1700-1800 Block of 23rd Street SE

Mission May Apartments – 23rd and Mission

**SUBJECT: PUBLIC WORKS RECOMMENDATIONS
SITE PLAN REVIEW SPR-DR17-16 (16-120896)
1700-1800 BLOCK OF 23RD STREET SE
96-UNIT APARTMENT COMPLEX**

PRELIMINARY GRADING AND DRAINAGE PLAN

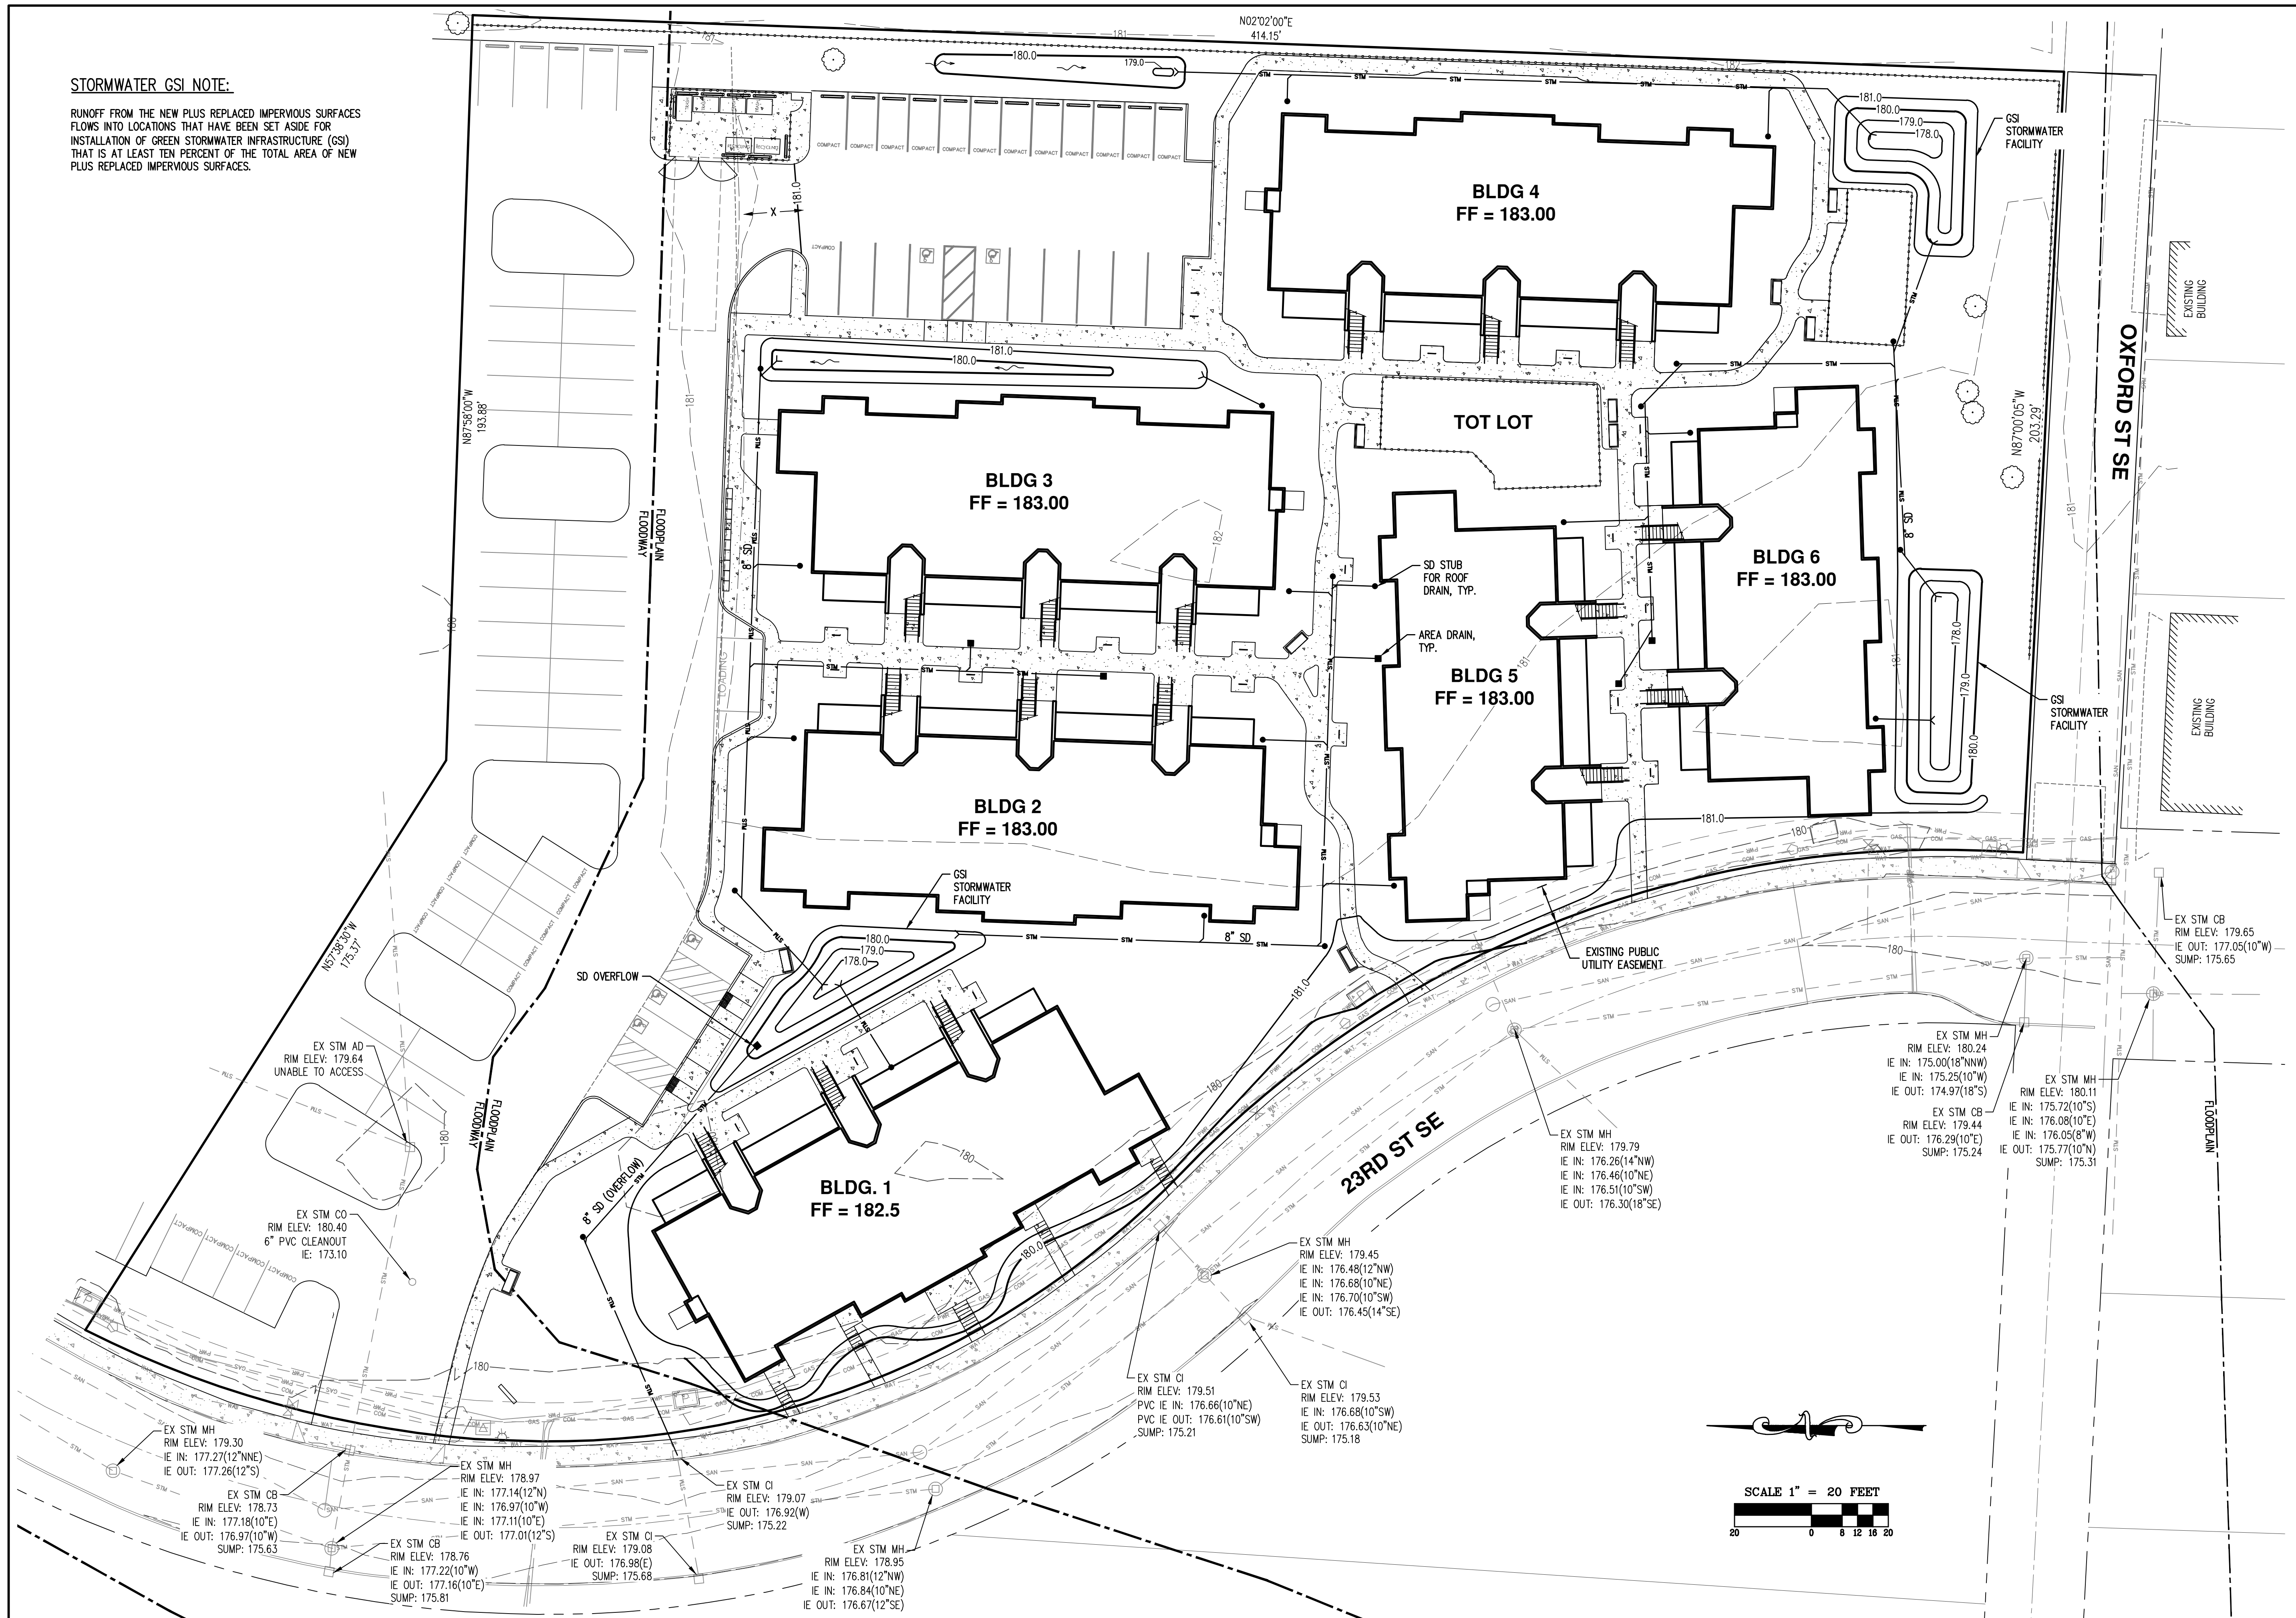
Finding—The subject property is designated on the Federal Emergency Management Agency (FEMA) floodplain maps as a Zone AE floodplain. Public Works staff has reviewed the Flood Insurance Study and Flood Insurance Rate Maps and has determined the

100-year base flood elevation of the subject development is 181 feet. Development within the floodplain requires a floodplain development permit and is subject to the requirements of SRC Chapter 601, including elevation of new structures to a minimum of 1-foot above the base flood elevation. An Elevation Certificate is required to verify the proposed structure's elevation. The Elevation Certificate shall be submitted to the City to verify the structure's elevation prior to pouring building foundations and again prior to final occupancy. The applicant's site plan indicates the proposed finish floor elevations will meet or exceed the minimum requirement of 182 feet.

1. Development within the floodway or floodplain requires a floodplain development permit and is subject to the requirements of SRC Chapter 601.
2. The existing unused driveway approaches to 23rd Street SE shall be removed and replaced with new curb and sidewalk.
3. Prior to final occupancy, a public easement shall be dedicated to the City of Salem for the proposed water meter, located on private property.
